LAND USE APPLICATION COMPLETENESS REVIEW

Subject Property: 2561 Center Street NE

Ref#: 23-123424-PLN

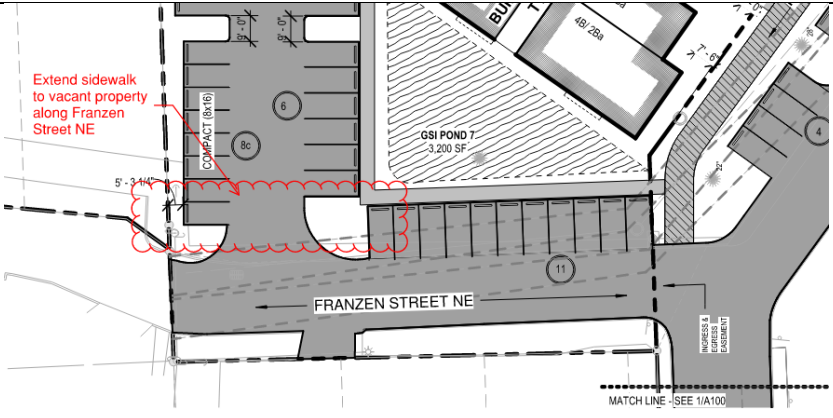
<p>Right-of-way Dedication – Radius (SPR and Partition Submittal Item)</p>	<p>As a condition of building permit approval, the applicant is required to dedicate right-of-way equal to 18-feet from centerline along Center Street NE as well as a 30-foot radius at the corner of Center Street NE and 23rd Street NE. The applicant shall show the radius dedication on the site plan to ensure compliance with setback requirements. Based on the plans submitted, it is unclear if the building at the corner of Center Street NE and 23rd Street NE will encroach into the required dedication area.</p> 
<p>Alternative Street Standard (SPR Submittal Item)</p>	<p>The applicant is proposing a street design that does not conform to SRC Chapter 803 for street standards. The application shall include findings for alternative street standards pursuant to SRC 803.065(a).</p> <ul style="list-style-type: none"> Street spacing and connectivity standards of SRC 803.030 and SRC 803.035(a) are not met. The applicant is proposing to construct a 10-foot wide shared use path through the development site and dedicate an easement

<p>for the path. Staff is supportive of this approach; however, written findings addressing the approval criteria are required. In addition, the plans do not address how connections will be made to existing sidewalks along the northern and southern portions of Medical Center Drive NE. See images below.</p> <ul style="list-style-type: none"> Curbline Sidewalks along 23rd Street SE and elimination of the required planter strip, please see comments under the “Street Tree Removal” section of this letter. Staff is not supportive of this alternative street standard. 
Title Report (Partition Submittal Item)	Submit a current title report for the subject properties for review by the Survey Section pursuant to SRC 205.030(b).
Land Division Application Type	According to the Survey Division: The applicant has applied for a three-parcel partition over two single and discrete units of land. Per ORS 92.010, you cannot move a property line with a partition. The applicant can apply for a two-parcel partition for tax lot 4000, then a property line adjustment to get the desired configuration between tax lots 3900 and 4000.

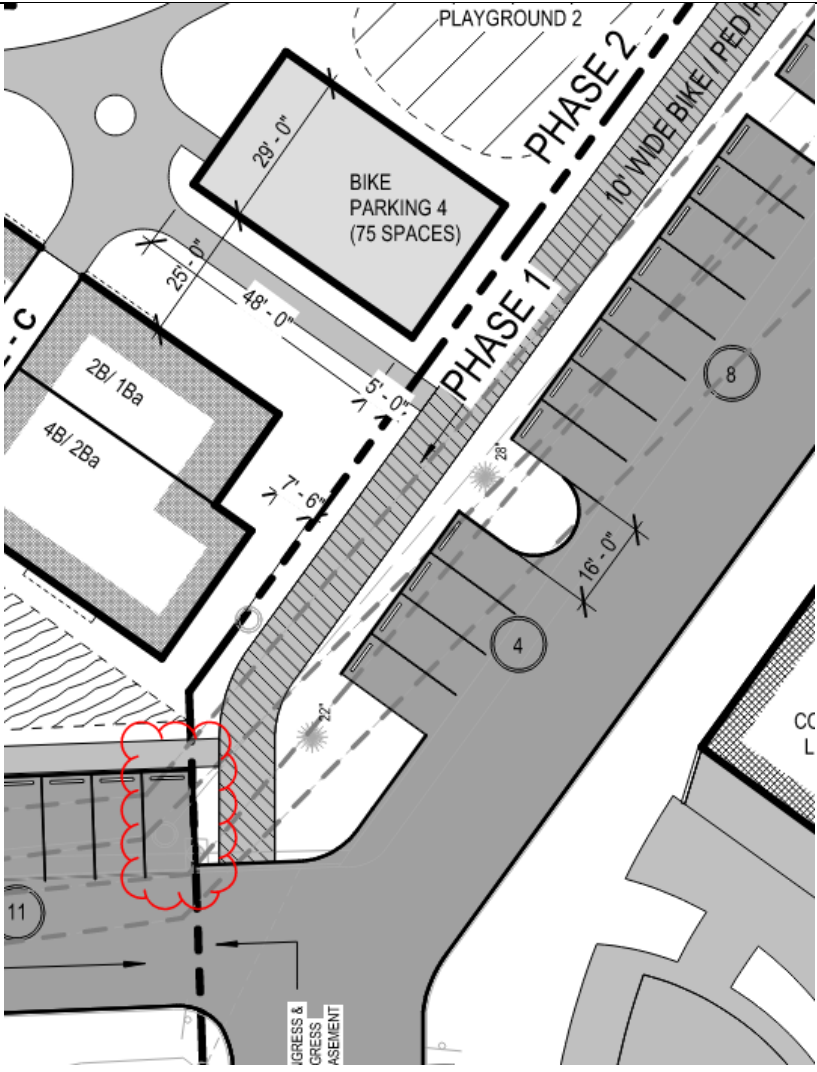
Sewer Capacity & UGA	As identified during the pre-application conference, there are known sanitary sewer basin capacity issues in the system the applicant shows connection to in Center Street NE. Public Works Utility Planning and Engineering has provided

<p>comments on the applicant's utility plans. Modifications may be necessary to address sanitary sewer capacity issues in the basin. The plans should be modified to serve as much of the northern portion of the property as possible with a new 8-inch public sanitary sewer main in 23rd Street SE to Monitor 511 Basin per comments on the plans.</p> <p>The applicant is encouraged to contact Keith Garlinghouse, Utilities Engineer, to discuss potential designs (KGARLINGHOUSE@cityofsalem.net). If the design results in a requirement for off-site sanitary sewer construction, an Urban Growth Preliminary Declaration (UGA) would be required to be submitted as part of the application package.</p>
<p>The following additional items are not "completeness" items but are advisories, which could result in conditions of approval or denial of applications.</p>	
<p>Building Setback Abutting a Street – SRC Chapter 533</p>	<p>Pursuant to Table 533-3, the maximum setback does not apply to a new building if another building exists between a minimum of 50 percent of the street-facing façade of the new building and the street. A GSI facility is proposed in the northeast corner of the property, a building does not exist between Building 9 and 23rd Street NE. Staff recommends moving Building 9 closer to 23rd Street NE if possible and moving the GSI facility.</p> <p>Pedestrian access should also be improved in this area, ideally connecting to the existing sidewalk at the shared driveway access.</p>  <p>The diagram is a site plan showing Building #9, which is a 'TYPE - C' building with sections labeled 3B/ 1.5Ba, 2B/ 1Ba, 4B/ 2Ba, and 2B/ 1Ba. To the right of the building is 'GSI POND 4' with an area of 4300 SF. The plan shows '23RD STREET' at the top and '23RD STREET SE' on the right. A red dashed line with an arrow points from the building area towards the street, with a red text label: 'Pedestrian connection here to connect with abutting property/street?'. Other labels include '18\"</p>

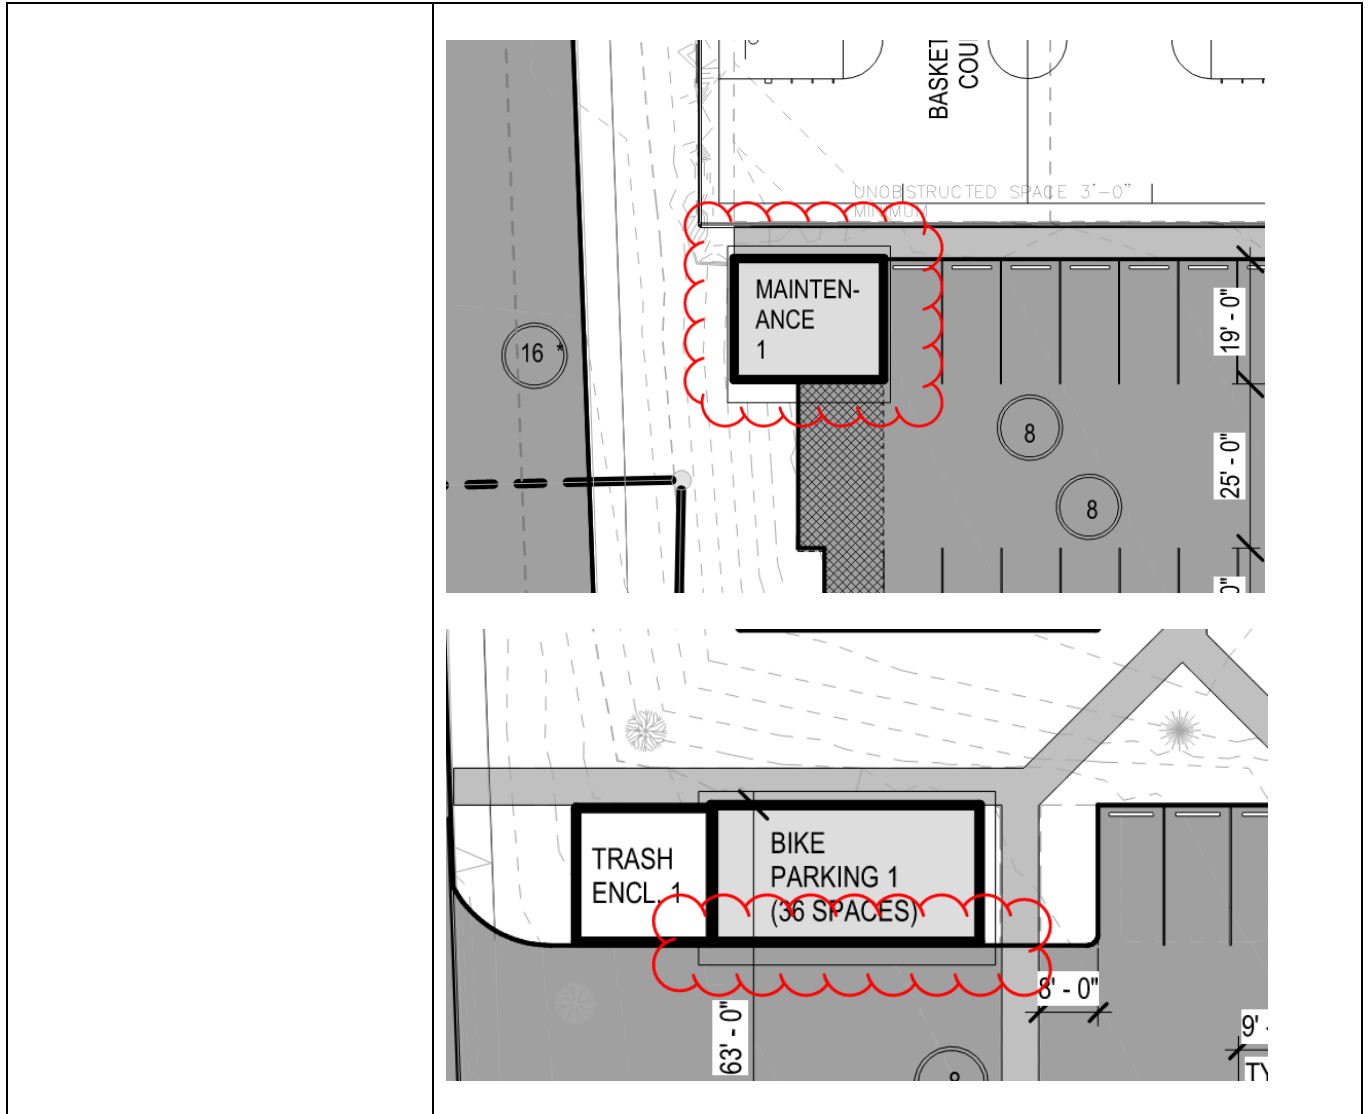
<p>Pedestrian Access Standards – SRC Chapter 800</p>	<p>Pursuant to SRC 800.065(a)(5), whenever a vehicular connection is provided from a development site to an abutting property, a pedestrian connection shall also be provided. Pedestrian access should be extended along Franzen Street NE to connect to abutting vacant property.</p>

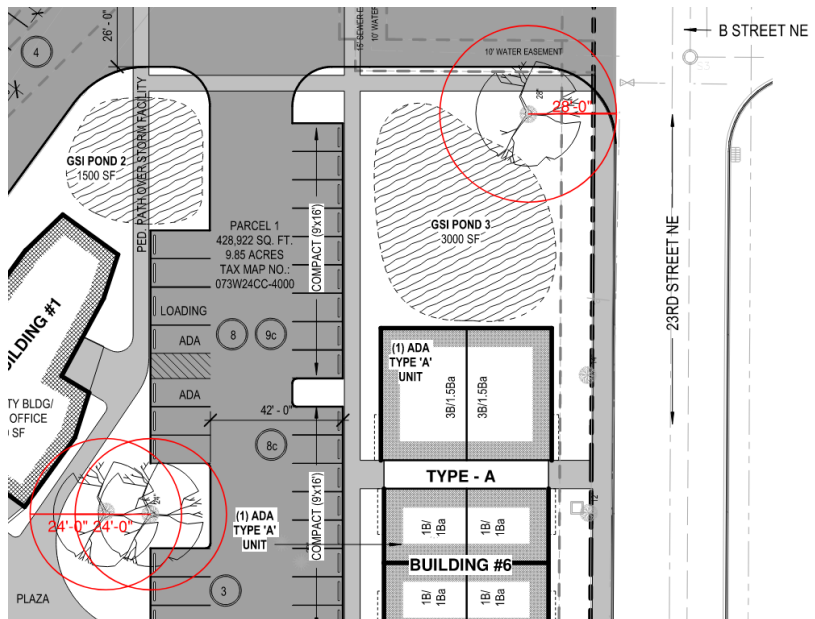
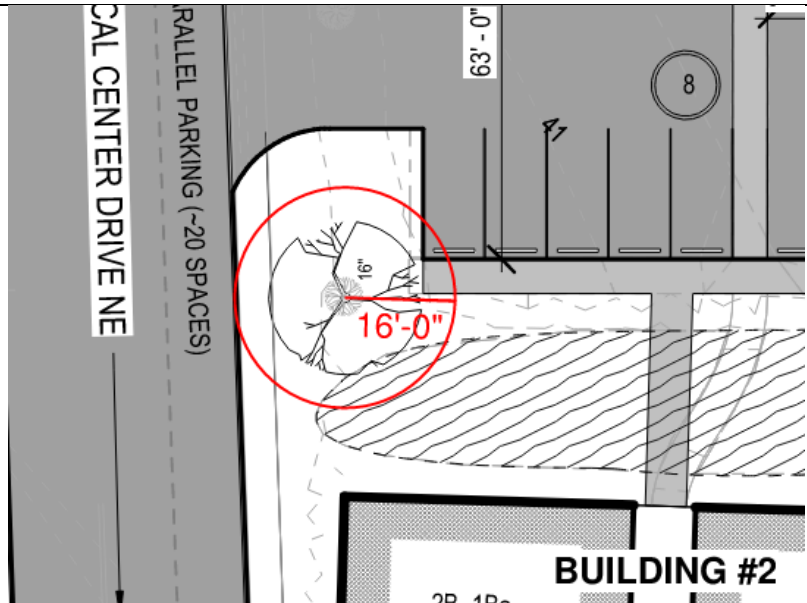
<p>Please revise the site plan to comply with the minimum standard.</p>
<p>Vehicle Use Area Setback Adjacent to a Building or Structure – SRC Chapter 806</p>	<p>Pursuant to SRC 806.035(c)(4), where an off-street parking or vehicular use area is located adjacent to a building or structure, the off-street parking or vehicular use area shall be setback from the exterior wall of the building or structure by a minimum five-foot-wide landscape strip or by a minimum five-foot-wide paved pedestrian walkway.</p> <p>Proposed maintenance buildings and bicycle storage buildings are placed throughout the off-street parking/vehicle use area without the minimum required setback. Please revise the site plan to comply with the minimum standard.</p>

<p>The top diagram shows a plan view of a parking area. A red scalloped line encloses a rectangular area labeled 'MAINTENANCE 2' and an adjacent area labeled 'COMPACT (8x16)'. To the right of the compact area are two circular spaces labeled '7c' and '8'. A dashed line at the top is labeled 'LOT LINE ADJ'. The bottom diagram shows another plan view. A red scalloped line encloses a rectangular area labeled 'BIKE PARKING 3 (36 SPACES)'. To the right of this area are two circular spaces labeled '4' and '9c'. Below these are two rows of rectangular spaces, with the bottom row labeled 'COMPACT (9x16)'. Dimensions are shown: '42'-0"' for the width of the bike parking area, and '19'-0"', '26'-0"', and '16'-0"' for the widths of the rows of compact spaces. A building footprint is labeled 'BU' in the top right corner.</p>
<p>Vehicle Use Area Maneuvering Requirements – SRC Chapter 806</p>	<p>Pursuant to SRC 806.035(f)(2), Where a drive aisle terminates at a dead-end, include a turnaround area as shown in Figure 806-9. The turnaround shall conform to the minimum dimensions set forth in Table 806-6.</p>

<p>The maneuvering area provided near Maintenance Building 1 does not comply with the minimum dimensions of Figure 806-9. Please revise the site plan to comply with the minimum standard.</p> 
<p>Landscape Plan and Tree Replanting – SRC Chapter 807</p>	<p>Several trees are proposed for removal from a setback area, and the total number of trees removed from the development site, as calculated under SRC 807.015(d)(2) may exceed 75%, requiring additional replanting of trees.</p> <p><i>Tree replanting requirements.</i> In addition to the landscaping required under this chapter are proposed for removal from within required setbacks or from a development site, replanting shall be required as provided in this subsection. The provisions of this subsection do not apply to lots used for single family uses, two family uses, three family uses, four family uses, or cottage clusters.</p> <p>(1) <i>Removal of trees within required setbacks.</i> When an existing tree or trees within a required setback are proposed for removal, two new trees shall be planted for each tree removed. Replanted trees shall be of either a shade or evergreen variety with a minimum 1.5 inch caliper.</p>

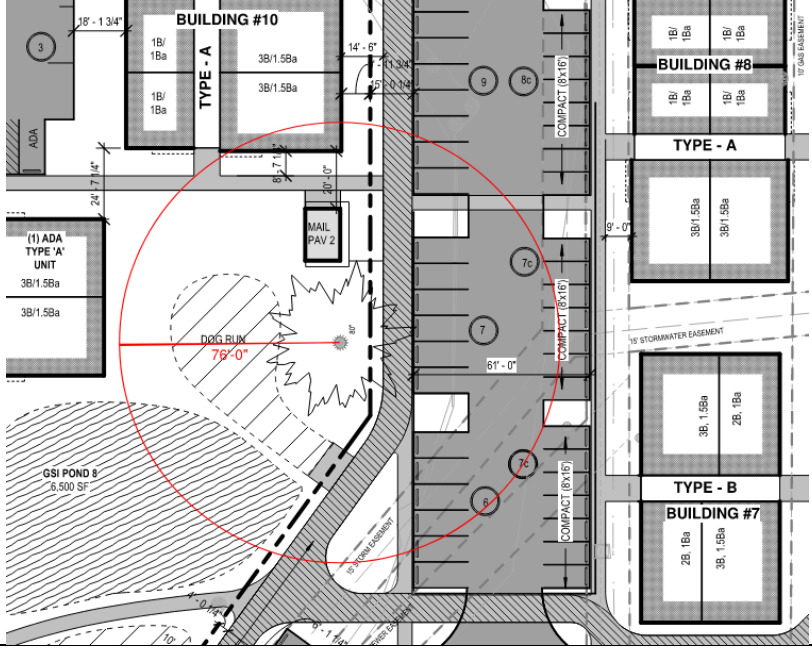
Tree 3602 is a Giant Sequoia with a dbh of 76". The approximate critical root zone is shown below. There is a significant amount of development activity occurring within the critical root zone of this significant tree. Steps should be taken to reduce the amount of grading and development activity in this area, in addition, encroachments into the CRZ will only be allowed following the recommendation of a certified arborist and demonstration that not more than 30 percent of the root zone will be impacted.
